Updates

V1.20 additions

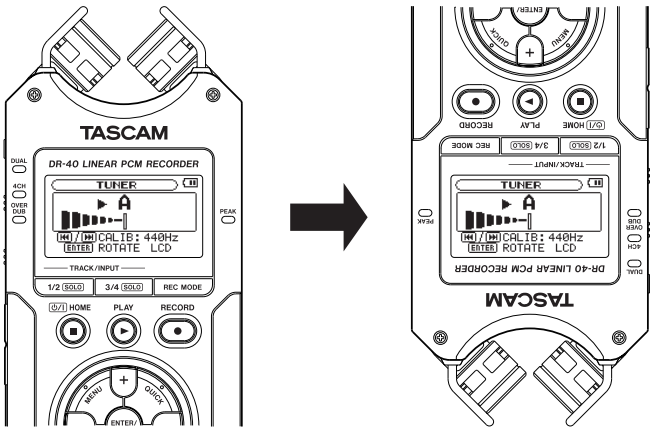
The tuner is now easier to use.

When the TUNER screen is open, you can press the **ENTER/MARK** button to reverse the screen orientation, making it easier to tune using the built-in mic.
